SITE PLAN APPROVAL APPLICATION

Project Location: 250 Main Street, Wolfville, NS Project Details: Addition to existing C2 residential building (add 5 units) PID: 55278642 This application must be accompanied by plans prepared by a qualified professional (i. e. engineer, architect, landscape architect, surveyor, etc.) as described in part 2.10 of the Land Use Bylaw. The plans are to be based on the best available and most current mapping or aerial images and include the following: North arrow, scale, legend, and drawing/revision dates. The type of plan (e.g. Site Plan) must appear in the title block in the lower right portion of the drawing. Stormwater Management Plan in accordance with the Town of Wolfville Stormwater Management Design Guidelines. Topographical Survey (no more than 5 years old) reflecting existing topographic and boundary conditions a key plan, property identification (PIDI) lot number, and/or civic number) and name of property owner. a key plan, property identification (PIDI) to number, and/or civic number) and name of property owner. of orbitin and area of proposed buildings, setbacks from all property boundaries and location of any existing building or structure

NORTH	
NORTH	
	/ `
SCALE	
	1:125
PROJECT NUMBER	
	FP24010
	FP24010
PROJECT	
250 MAIN STREET,	
WOLFVILLE, NS	
PHASE 2	
TITLE	
LANDSCAPE PLAN

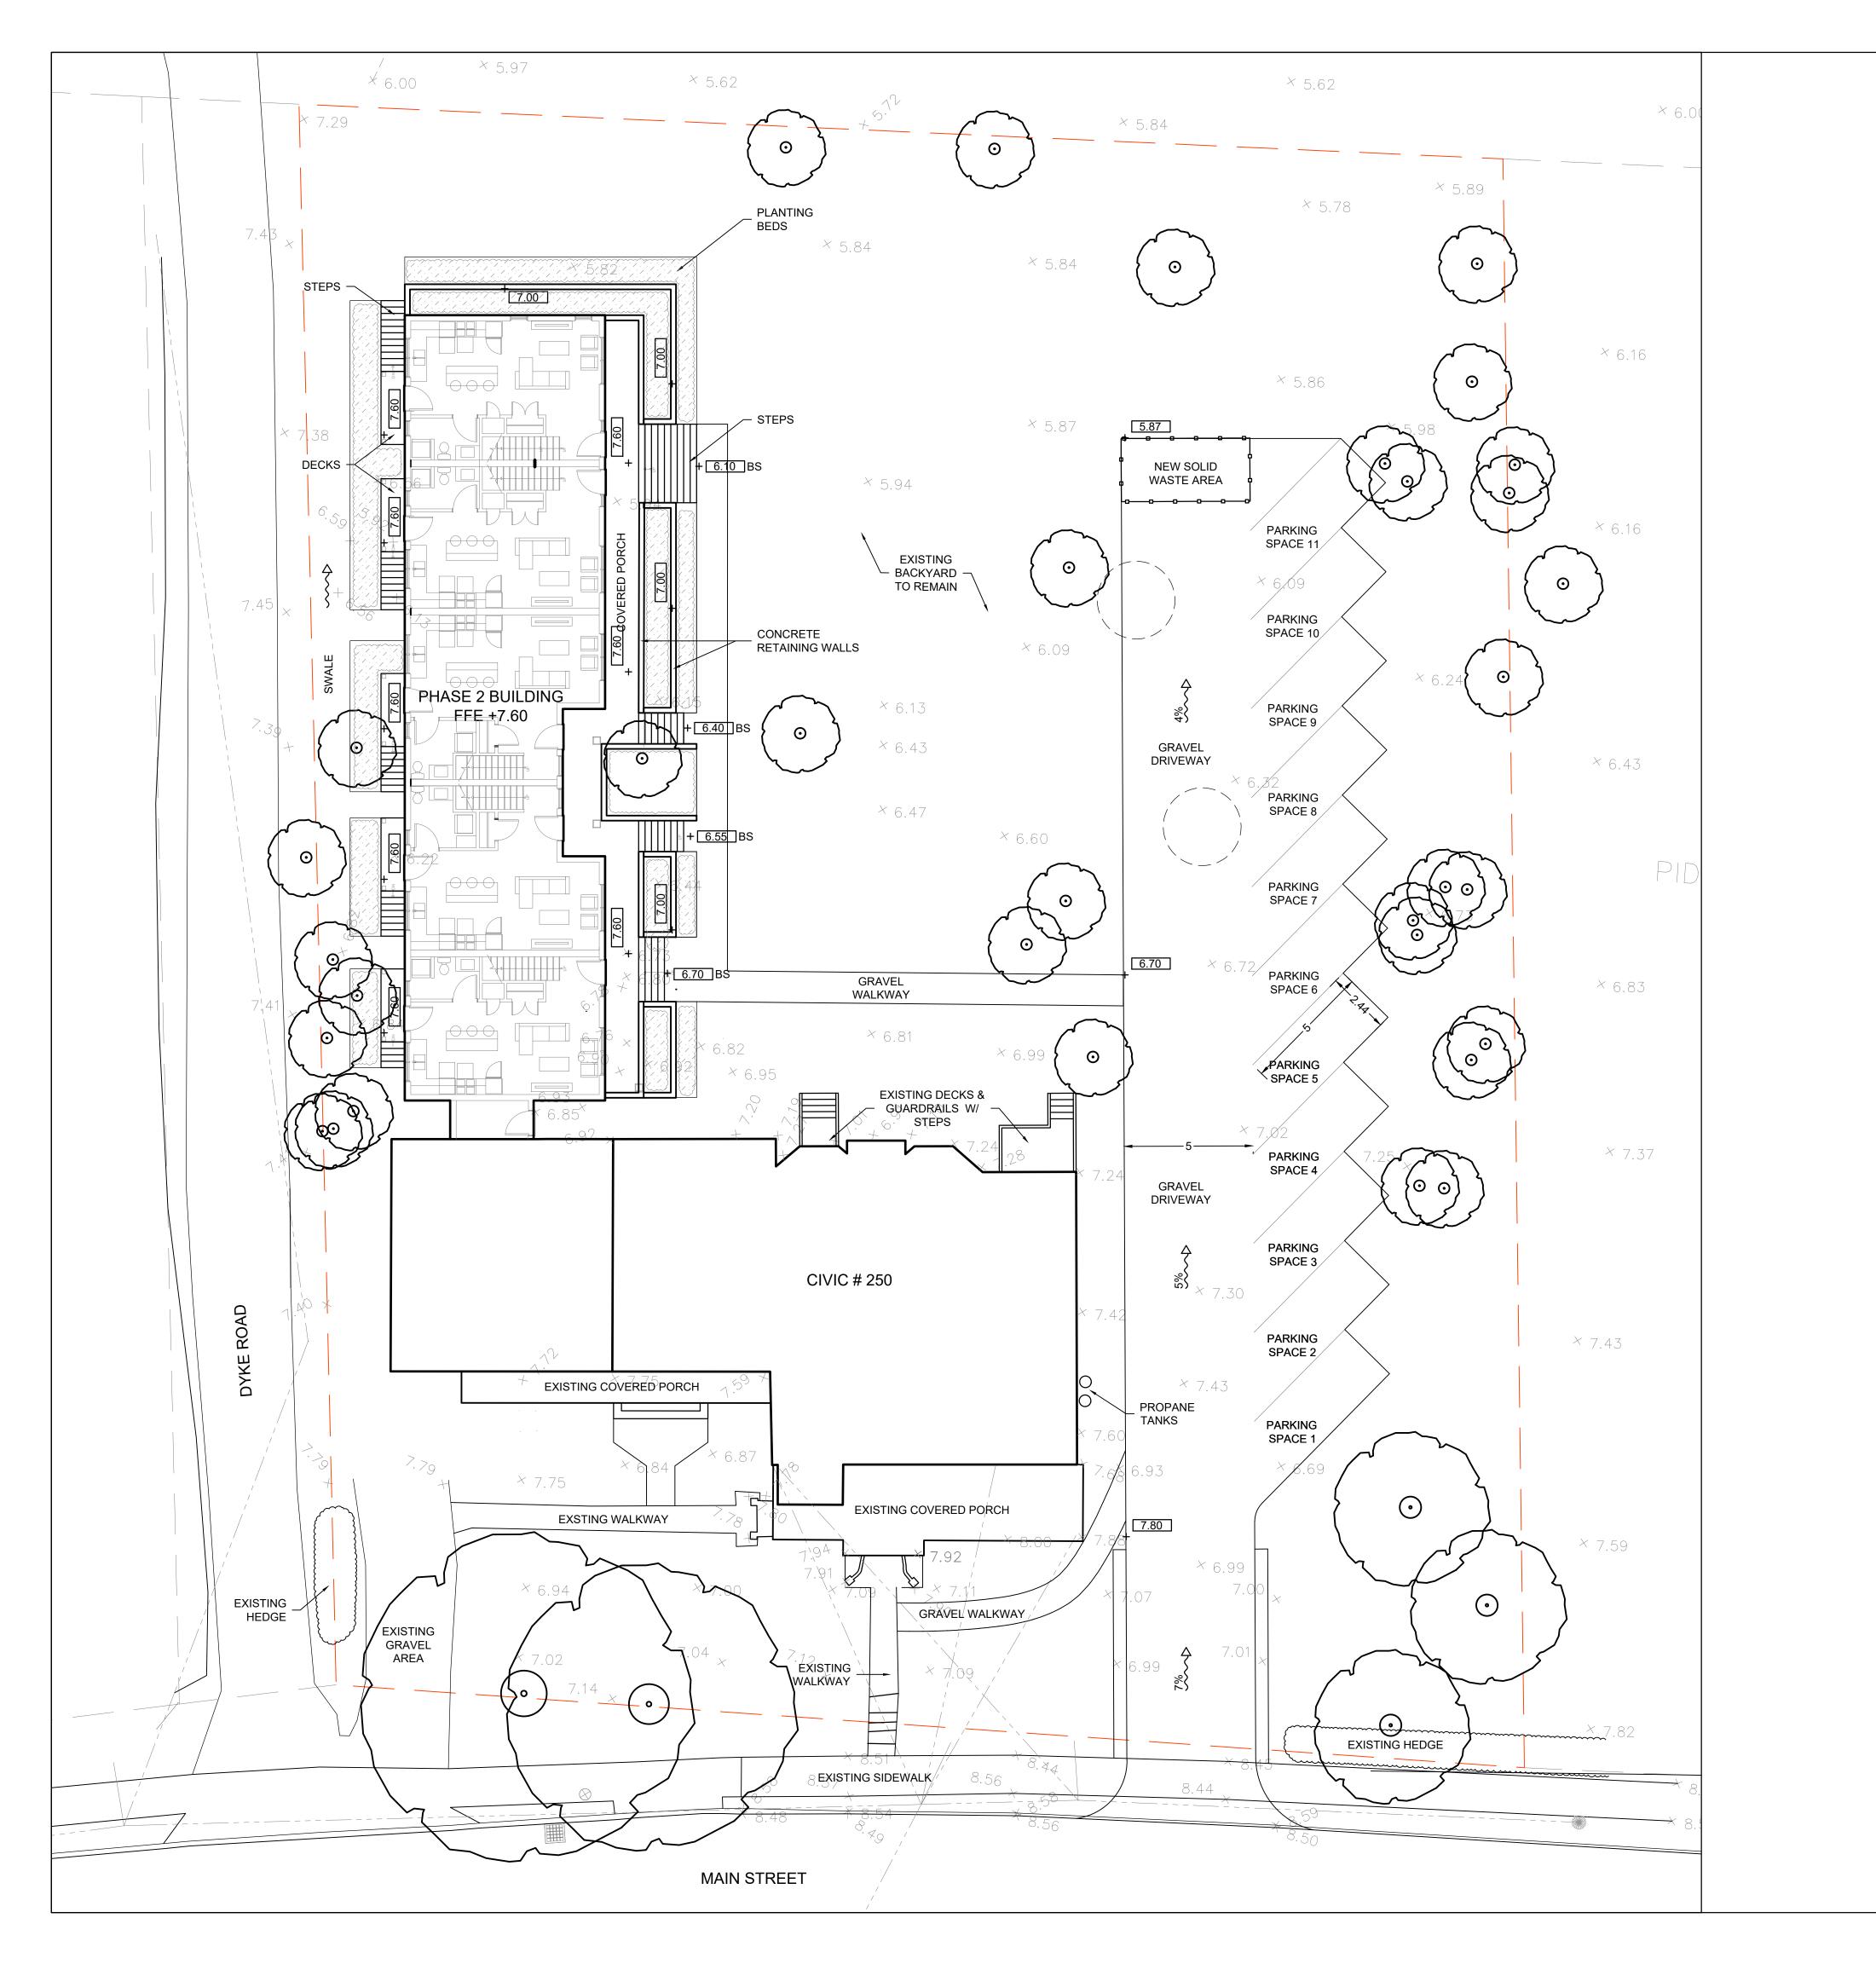
4.	The type, location, and height of walls, fences, hedges, trees, shrubs, ground cover or other landscaping elements which is necessary to protect and minimize negative land use impact on neighbouring properties;	Existing landscaping will be retained as much as possible and more will be added should negative impacts to neighbouring properties arise. Tree retention plan by a qualified arborist will be required for the large trees on the property.

15. The Development Officer may vary any of the prescriptive dimensional requirements by up to 10 percent of the requirements to allow some flexibility to accommodate physical anomalies of a site, so long as the intent of the particular requirement is not compromised.	New driveway width has been reduced to 5m and parking spaces reduced slightly to accommodate retaining mature trees.
